Delegated Report

Householder Planning Application

Planning Application No: 20230334

Description: Retrospective retaining wall and area of hardstanding, and proposed dropped kerb to allow vehicle access.

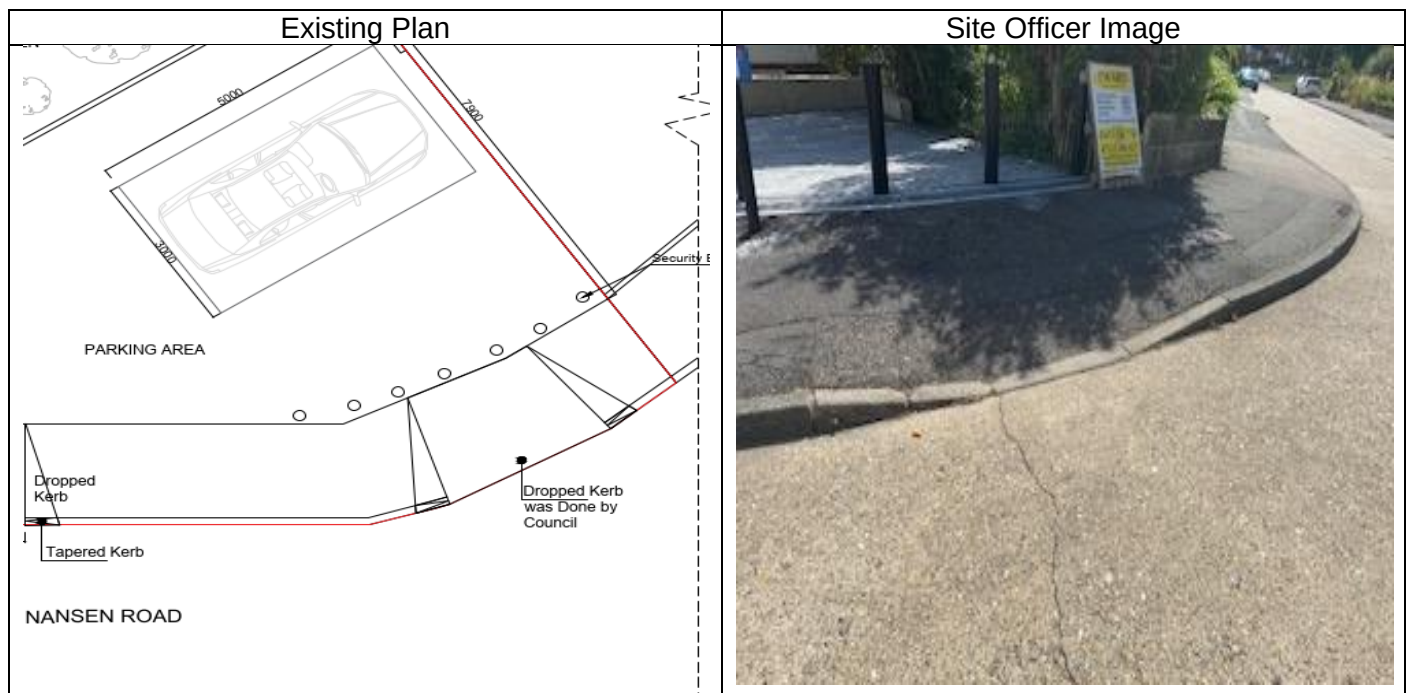
Prior to existing works to the frontage, the property benefitted from a low-level boundary wall, mature hedging and landscaping and a laid to lawn front garden. This had a positive contribution to the visual amenity to the street scene and area as a whole.

The submitted 'Existing Plan' shows the retention / planting of several trees and hedges to the area between the hardstanding and the dwelling. However, as noted at the site inspection, the proposed soft landscaping has not been implemented.

The removal of the soft landscaping and the laying of hardstanding has resulted in a hardening of the street scene which benefits from these pockets of soft landscaping in the form of boundary hedging and laid to lawn front gardens. It is noted that a small amount of soft landscaping adjacent to the steps leading to the property has been retained. However, this is considered to be minimal and does little to offset the hardened appearance of the front of the plot.
